SITE PROBLEM REPORT

CUSTOMER Metropolitan Edison CONTRACT NO. 0005 SPR NO. 41 SPR REV. NO. 00

TITLE (MAX. 30 SPACES) Pressurizer Level Compensation

BAILEY METER COMPANY
DETAILED SCHEMATIC
REACTOR COOLANT PART 1

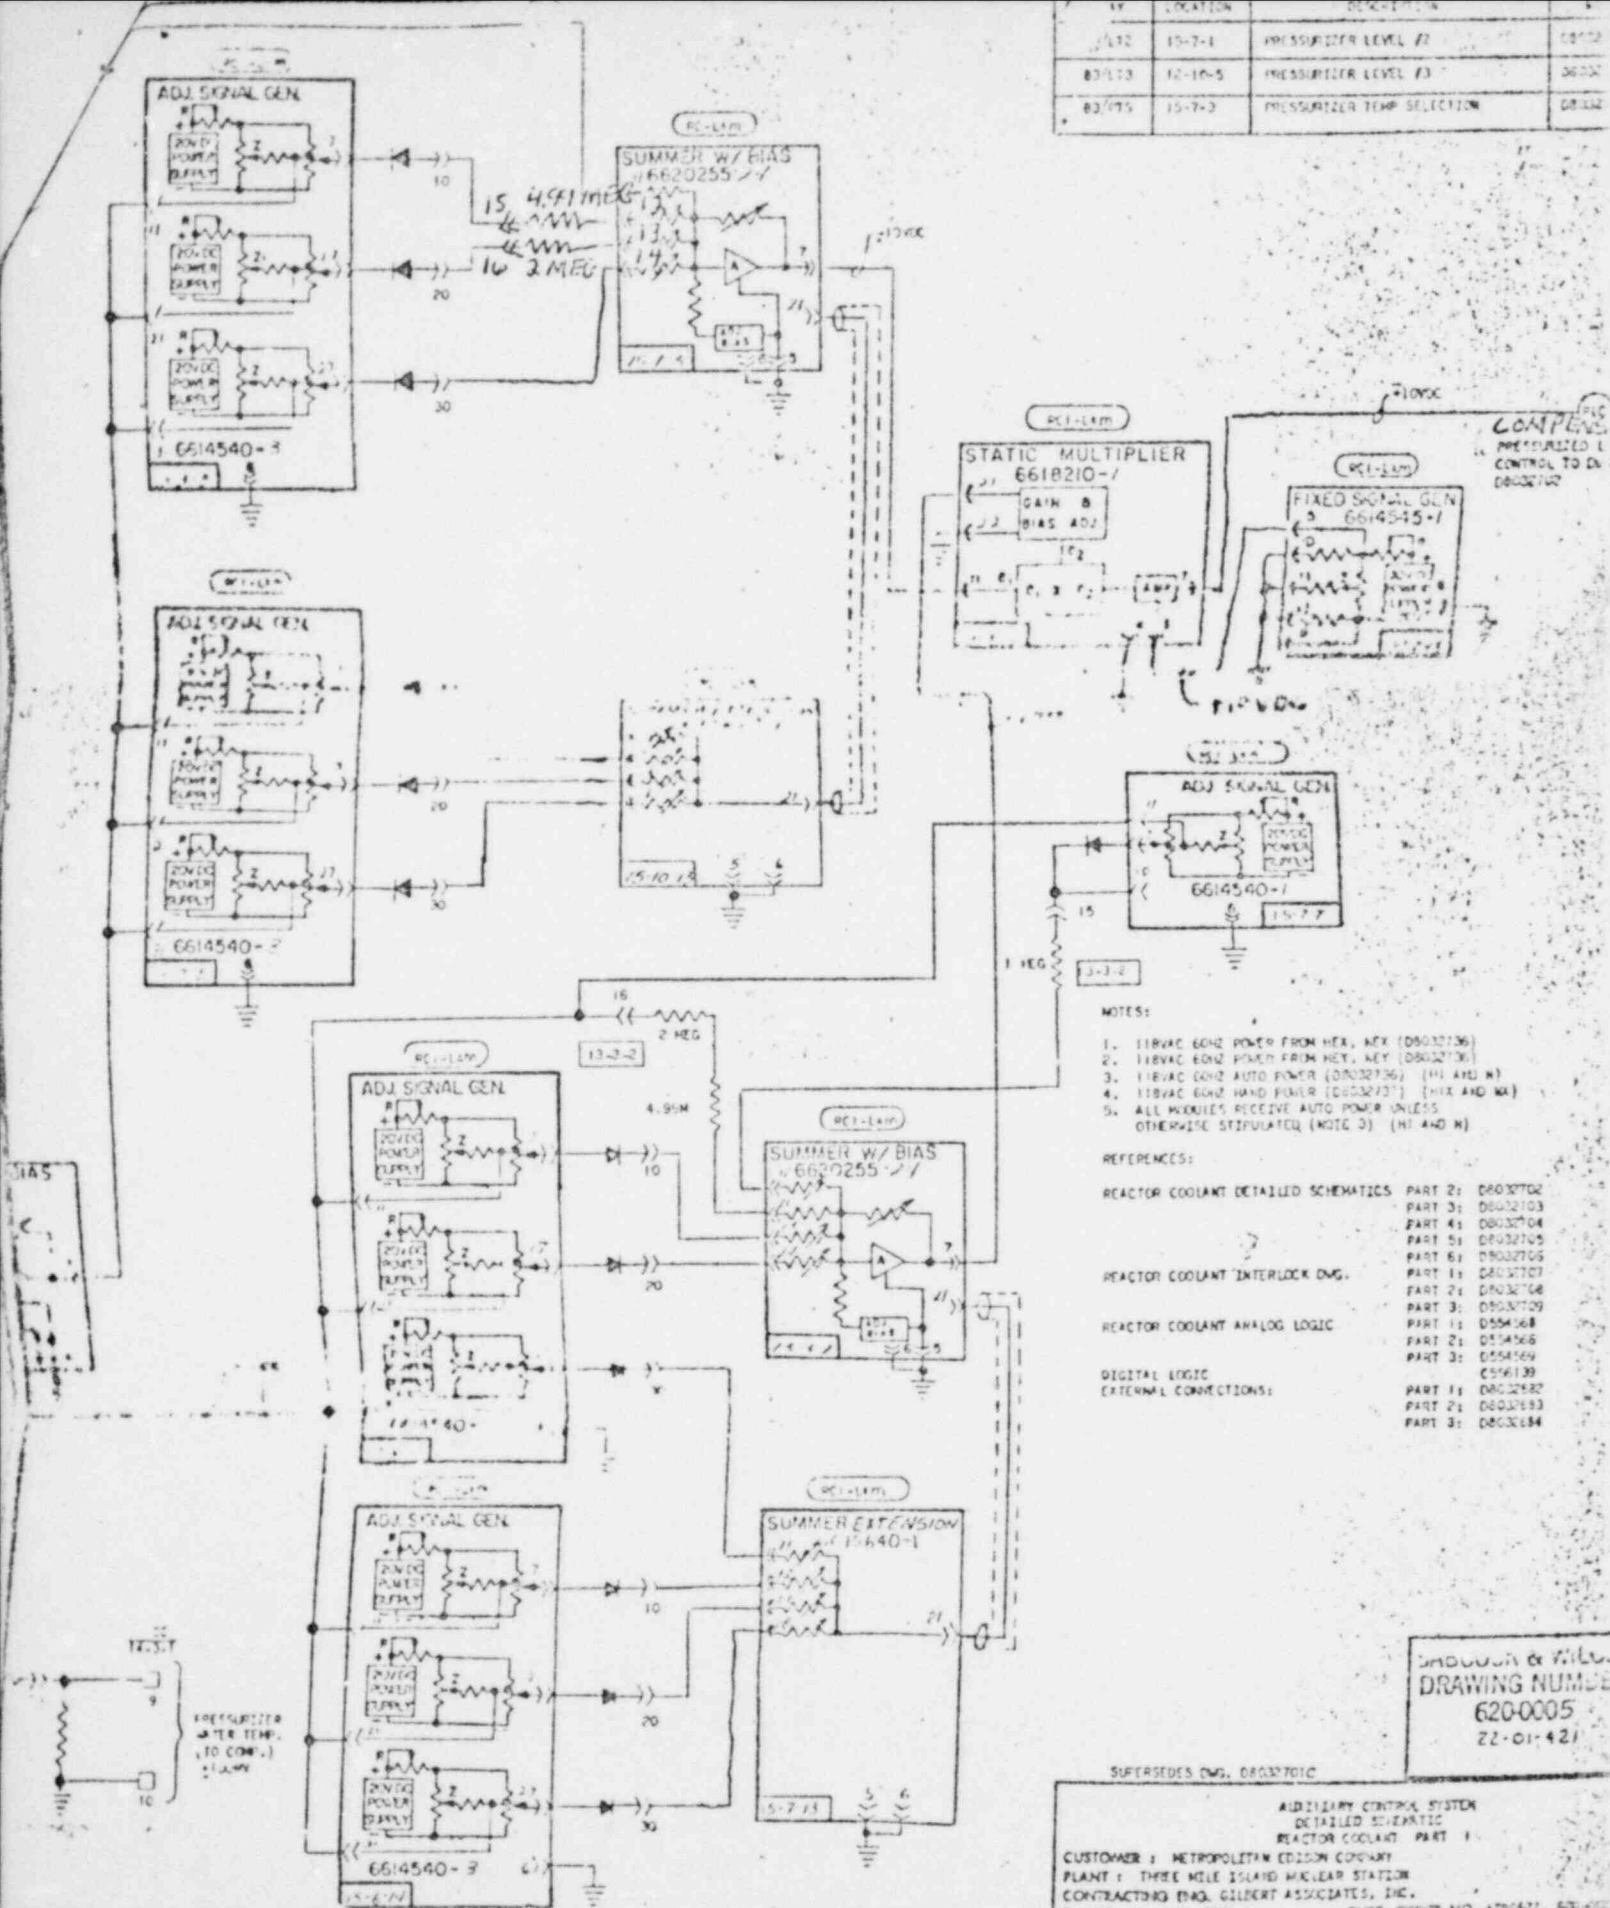
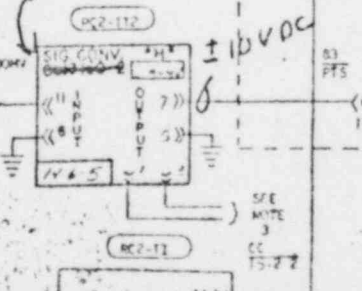
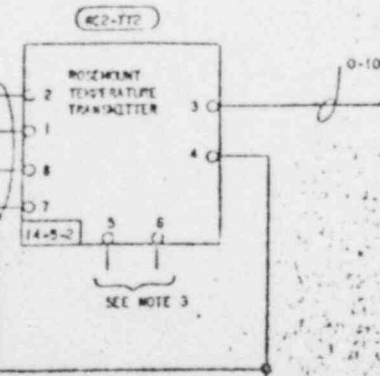
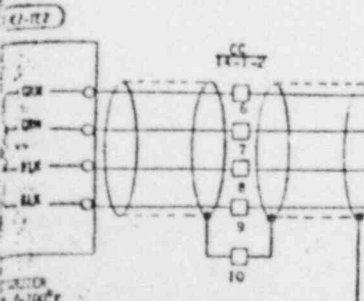
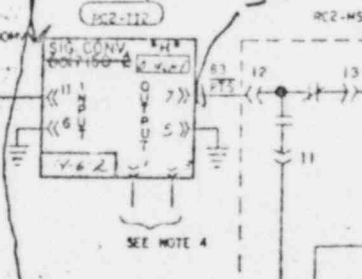
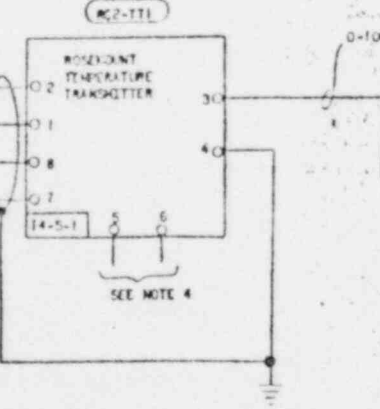
DESCRIPTION OF PROBLEM See attached Bailey Meter Company Problem Report.

UNCOMPENSATED
PRESSURIZER LEVEL (TO COMP.) 0.100MP

FURTHER ACTION REQUIRED BY OTHER THAN SITE PERSONNEL Bailey Meter Company to resolve. This SPR is forwarded to B&W for information only.

RECOMMENDED ACTION FC 10015 complete
